DATE: July 11, 2012

TO: All Prospective Bidders

SUBJECT: Addendum No. 2
 US 50 HOV Lanes Phase 0 El Dorado Hills Interchange
 Project
 Contract No. PW 12-30639, CIP No. 53124

CSS-1

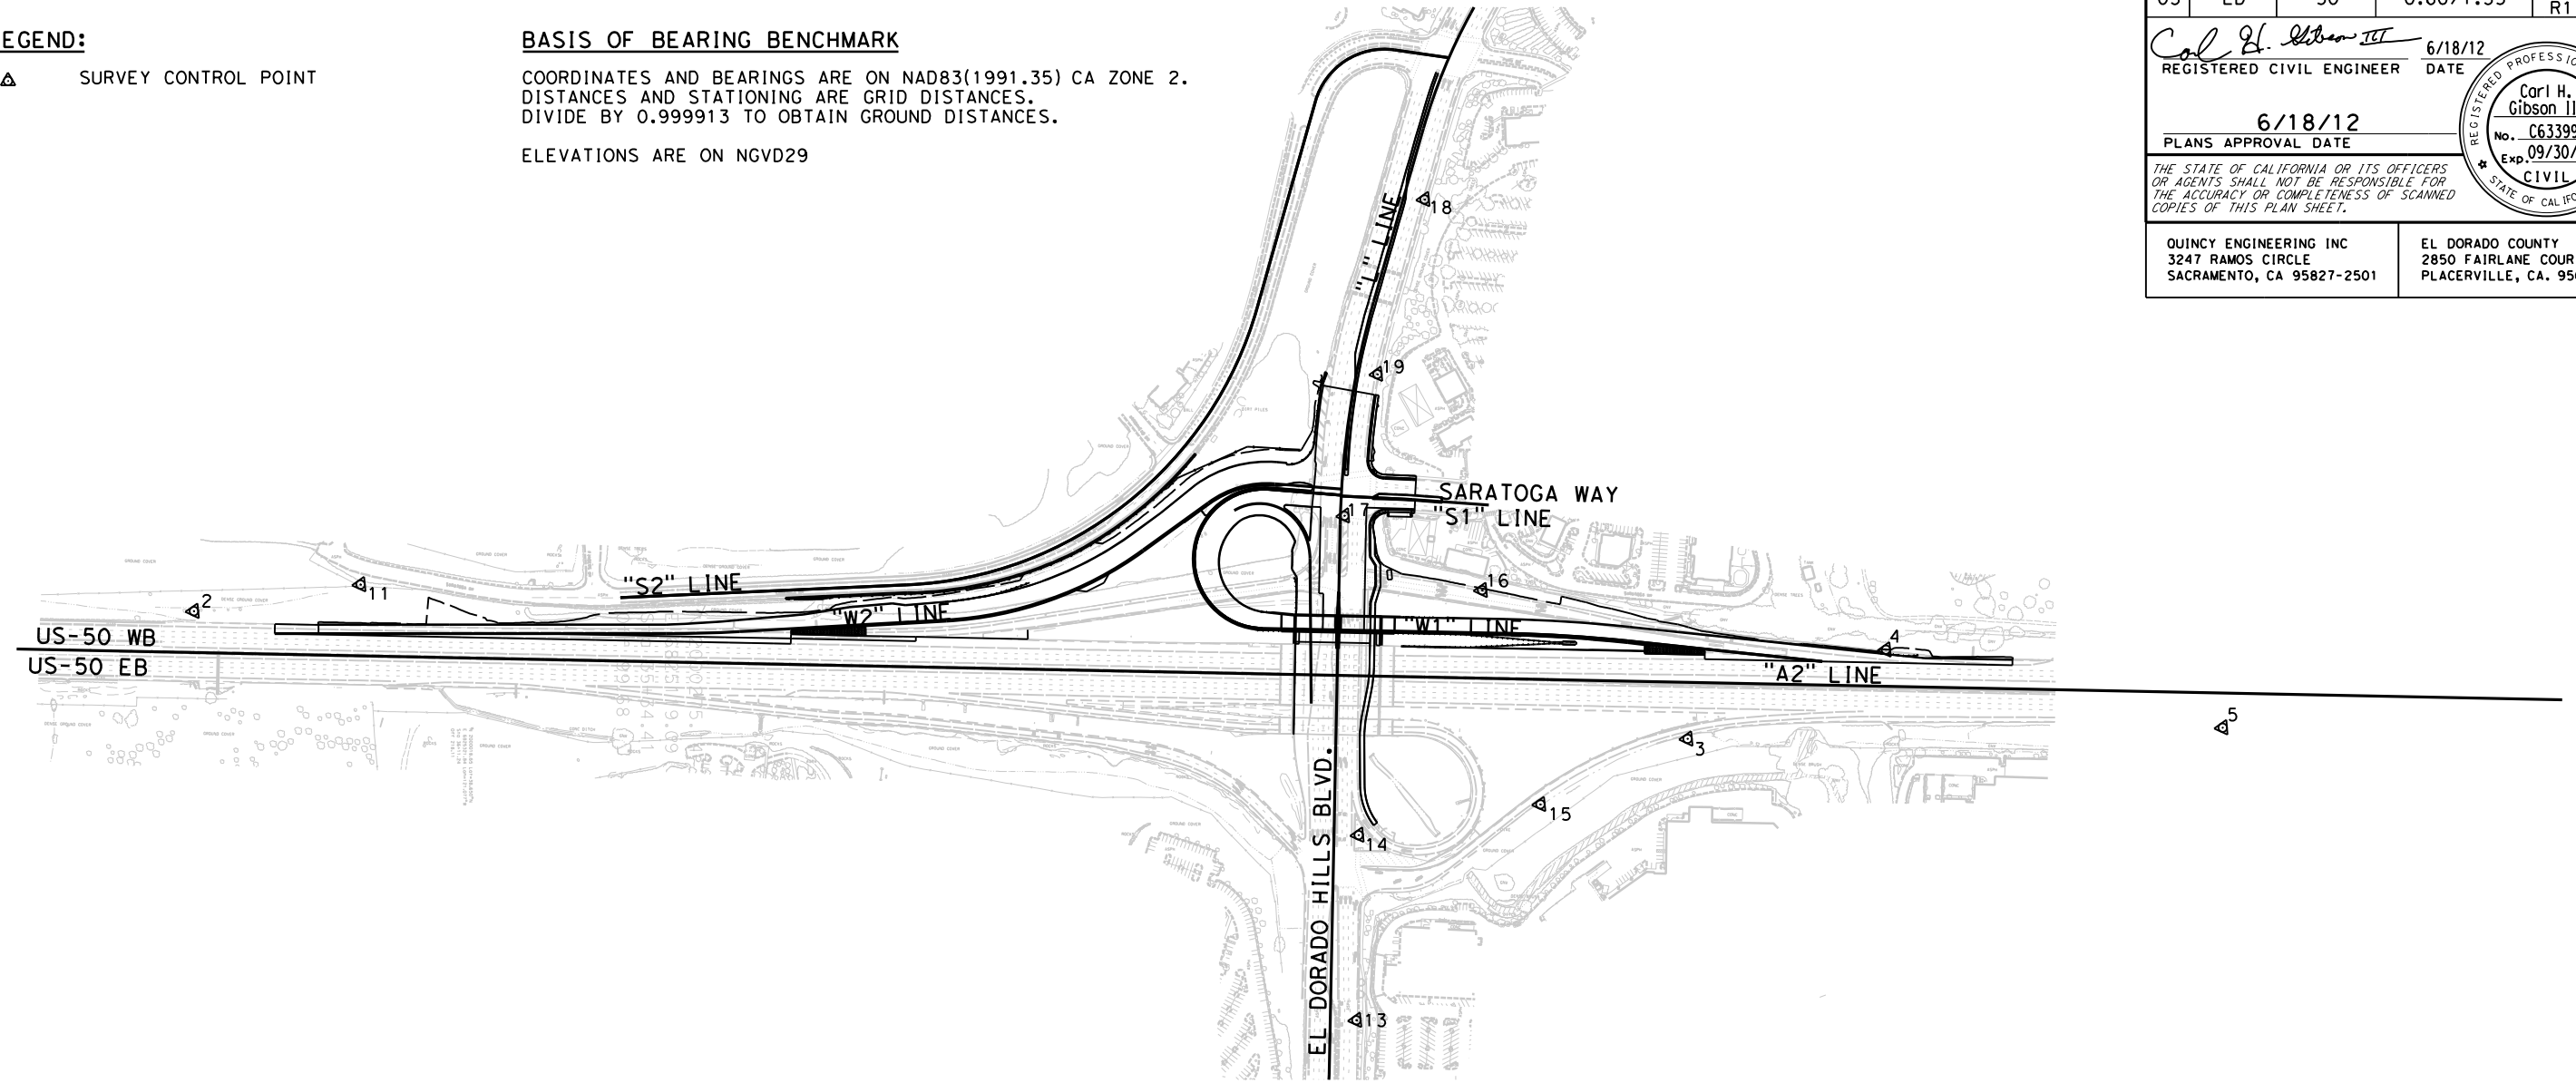
MARK	DATE	DESCRIPTIONS	BY	CH'D
▲	7-12	SURVEY CONTROL DATA REVISIONS	VFD	CG3
REVISIONS

TYPICAL CROSS SECTIONS
NO SCALE
X-1

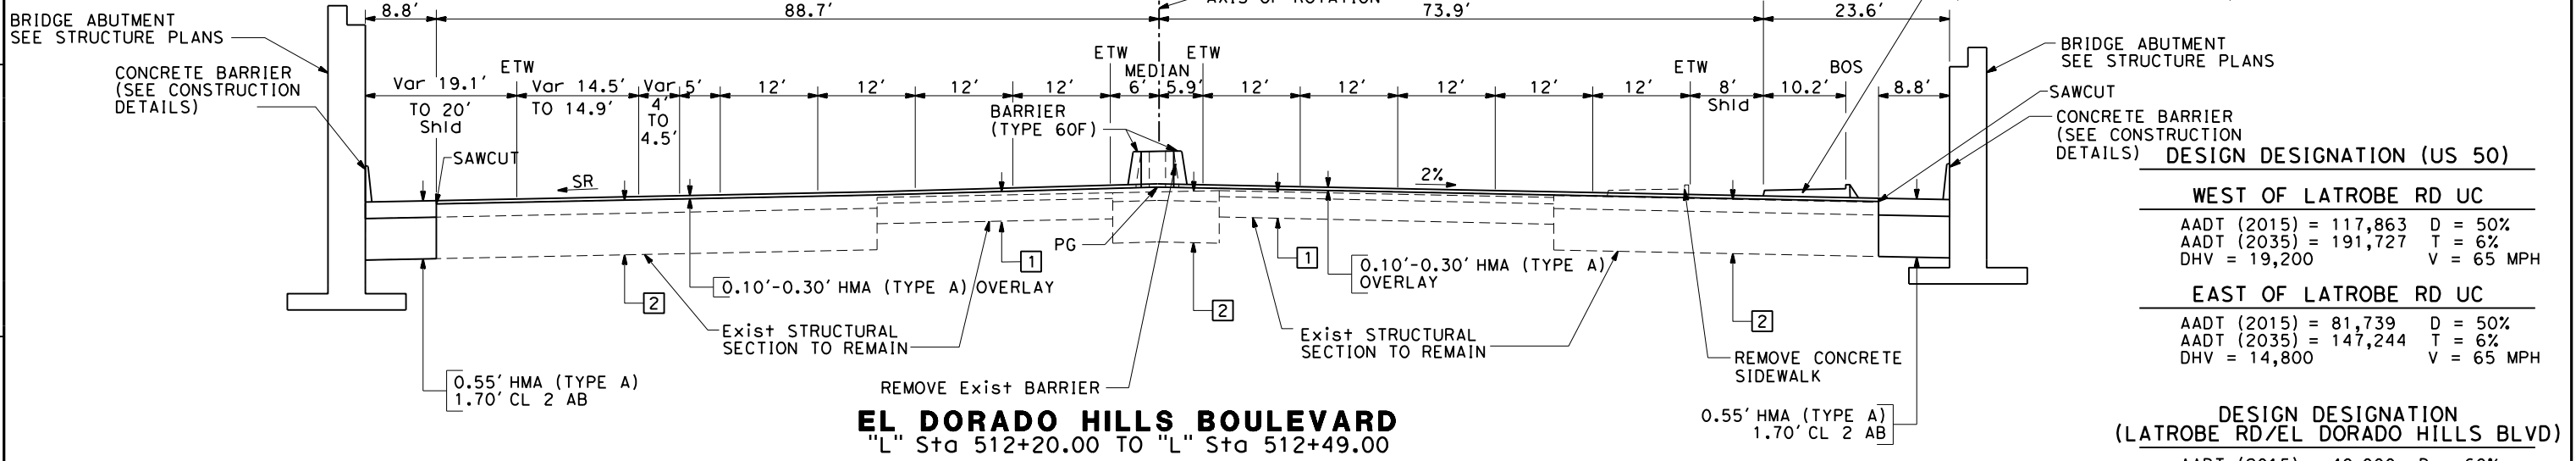
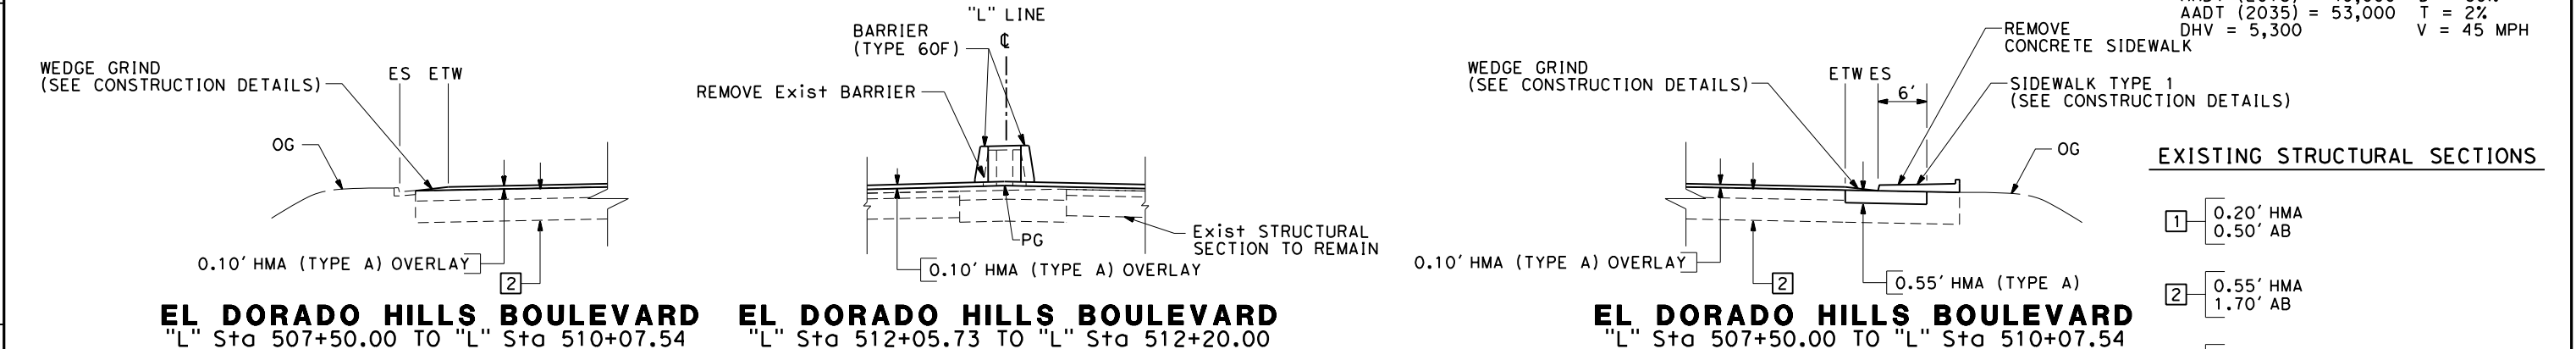
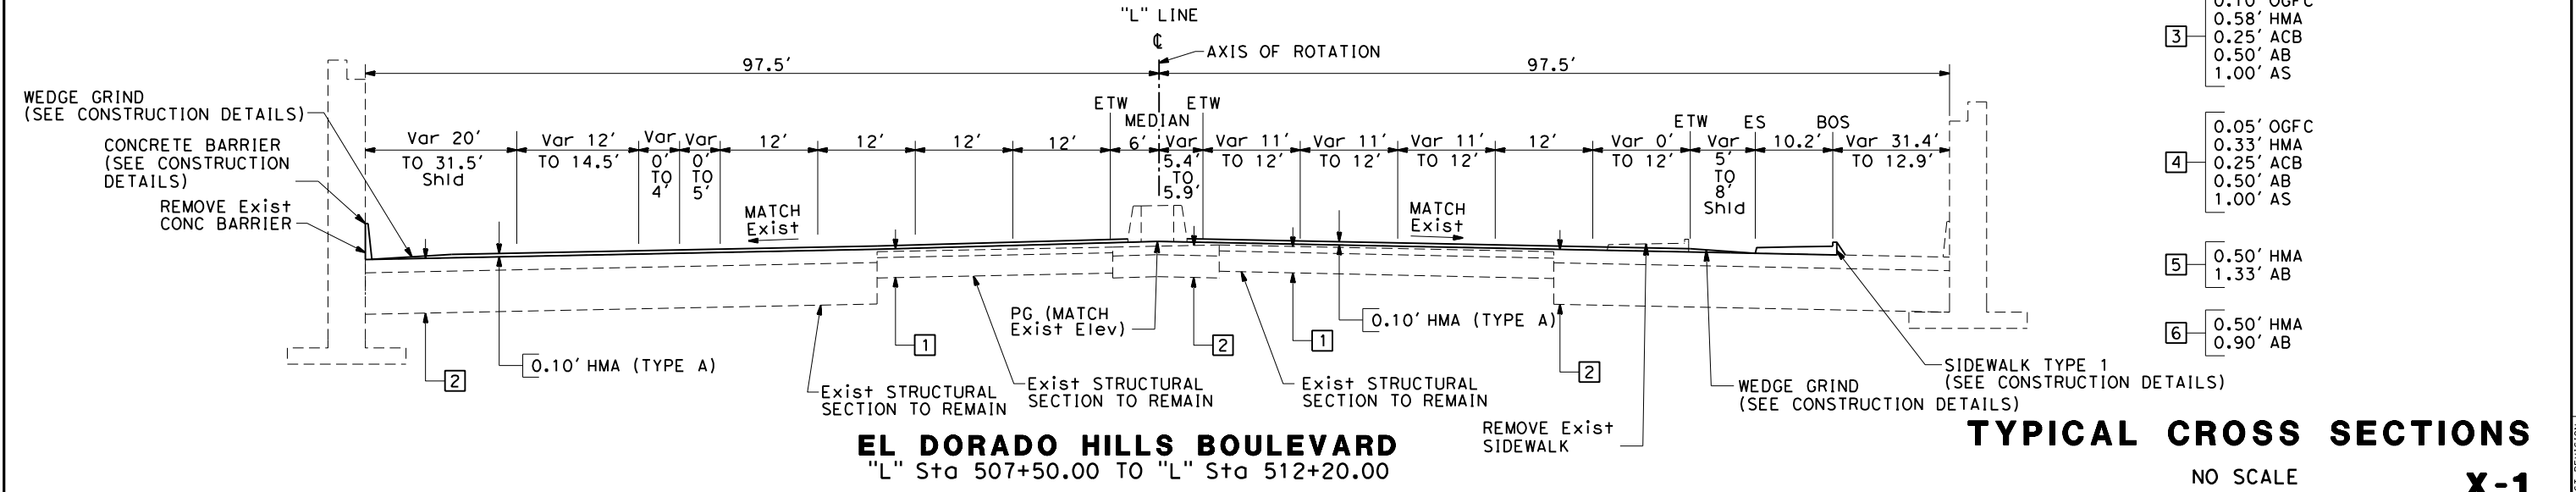
MARK	DATE	DESCRIPTIONS	BY	CH'D
7-12		HOT MIX ASPHALT (DEEP LIFT) REVISIONS	VFD	CG3
REVISIONS

1. DIMENSIONS OF THE PAVEMENT STRUCTURES (STRUCTURAL SECTIONS) ARE SUBJECT TO TOLERANCES SPECIFIED IN THE STANDARD SPECIFICATIONS.
2. SHOULDER AREAS WITH SUPERELEVATIONS SHALL BE PAVED RHMA-O FROM EDGE OF TRAVELWAY TO EDGE OF TRAVELWAY OR AS DIRECTED BY THE ENGINEER.
3. SEE SUMMARY OF QUANTITY SHEETS AND CONSTRUCTION DETAIL SHEETS FOR EXACT LOCATIONS OF METAL BEAM GUARD RAILING.
4. SEE SUMMARY OF QUANTITY SHEETS AND LAYOUT SHEETS FOR EXACT LOCATIONS AND TYPE OF DIKE.
5. SEE SUMMARY OF QUANTITY SHEETS AND CONSTRUCTION DETAIL SHEETS FOR EXACT LOCATIONS OF CONCRETE BARRIER.
6. SEE DRAINAGE SHEETS FOR EXACT LOCATIONS OF MEDIAN FLOW LINE.
7. SEE DRAINAGE DETAIL SHEETS FOR LOCATIONS AND THICKNESS OF DITCHES.
8. SUPERELEVATIONS ARE SHOWN ON THE SUPERELEVATION DIAGRAMS.
9. ALL HMA, EXCEPT FINAL LIFT, SHALL BE HOT MIX ASPHALT (DEEP LIFT).

TYPICAL CROSS SECTIONS
 NO SCALE
X-2

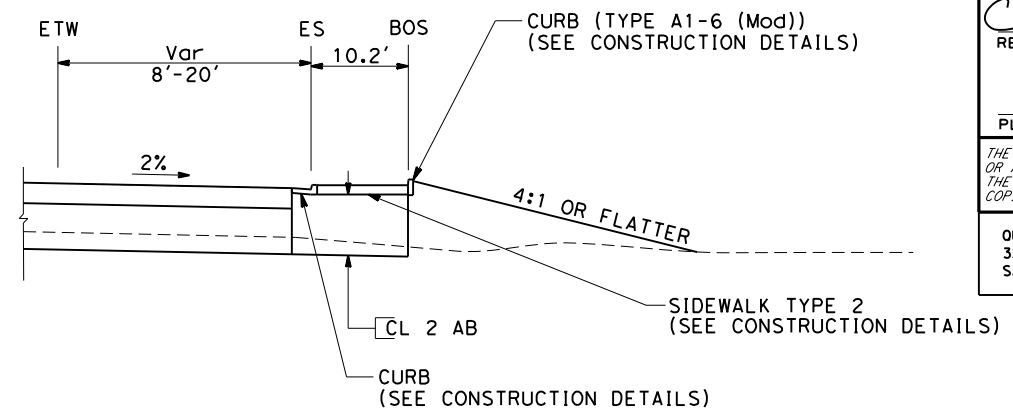
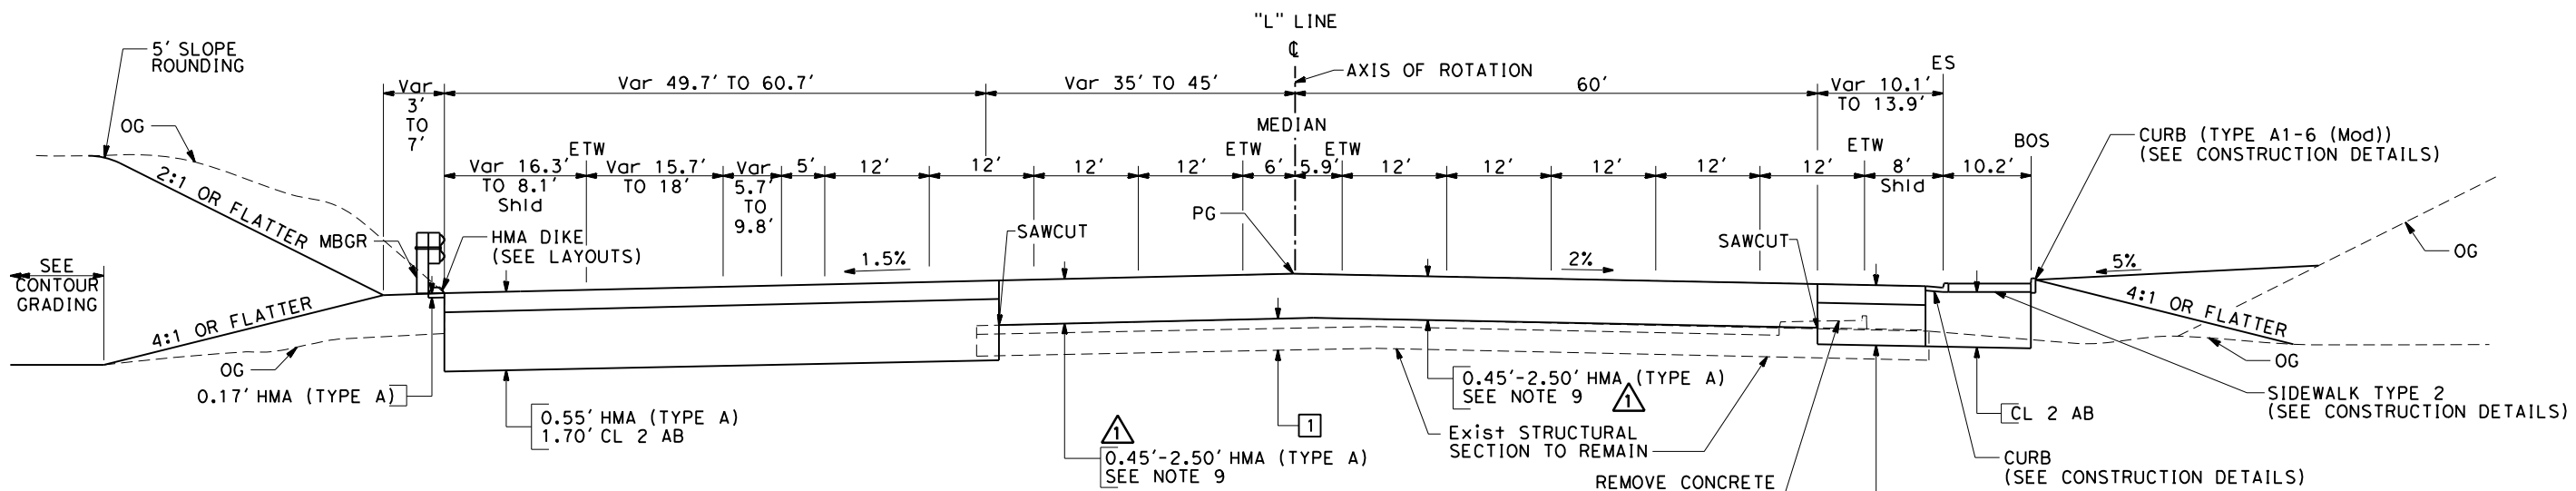
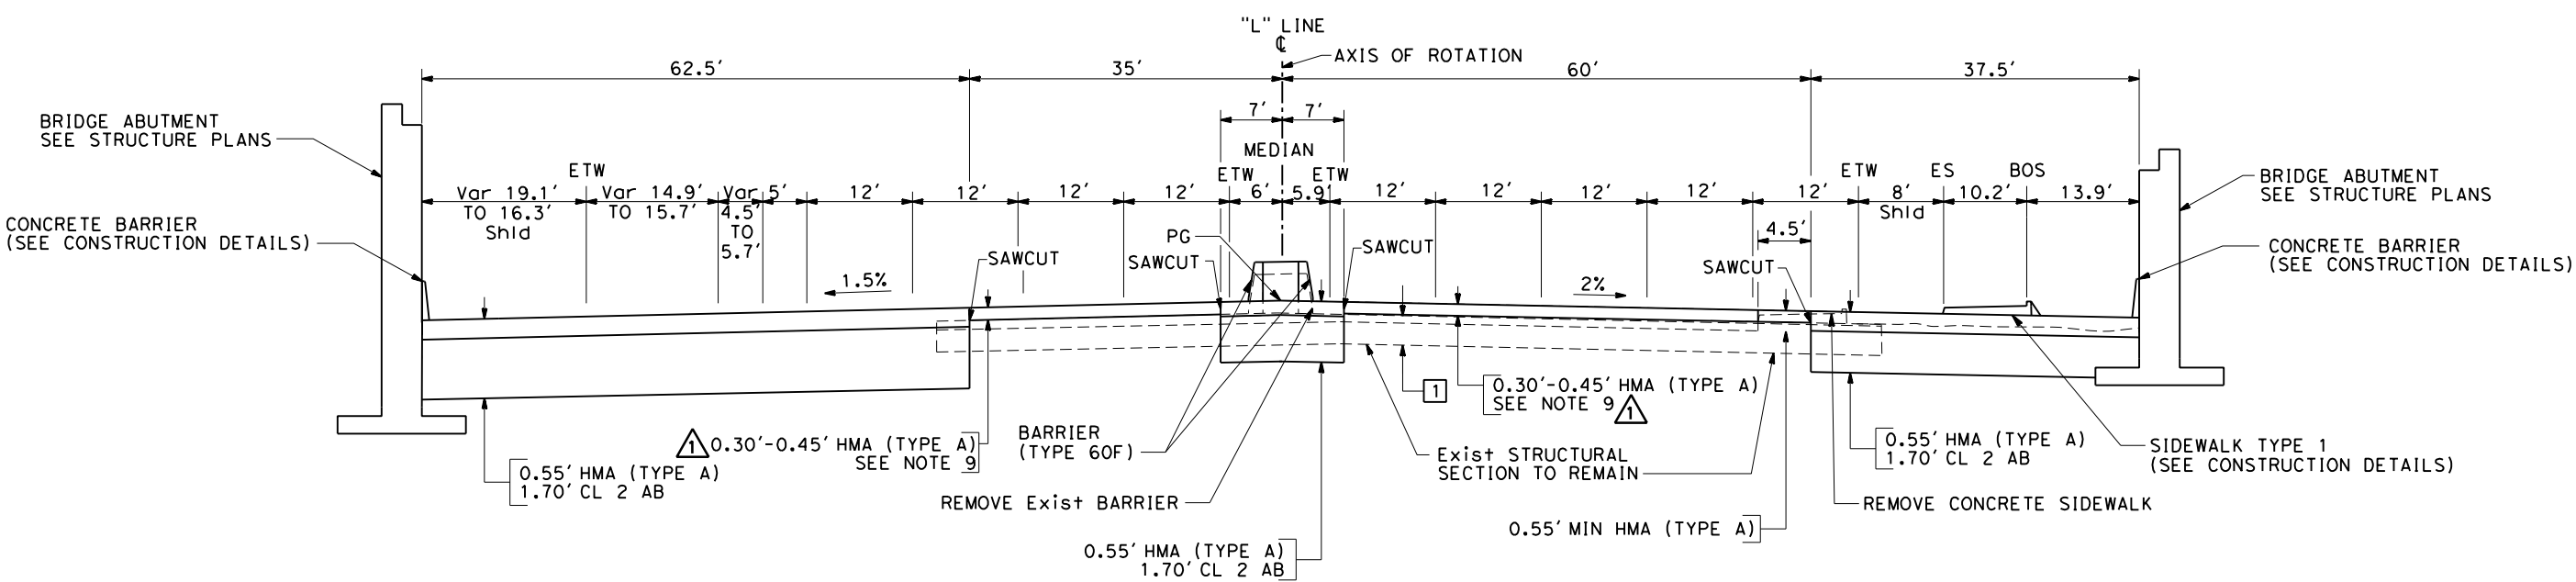
MARK	DATE	DESCRIPTIONS	BY	CH'D
7-12		HOT MIX ASPHALT (DEEP LIFT) REVISIONS	VFD	CG3
REVISIONS
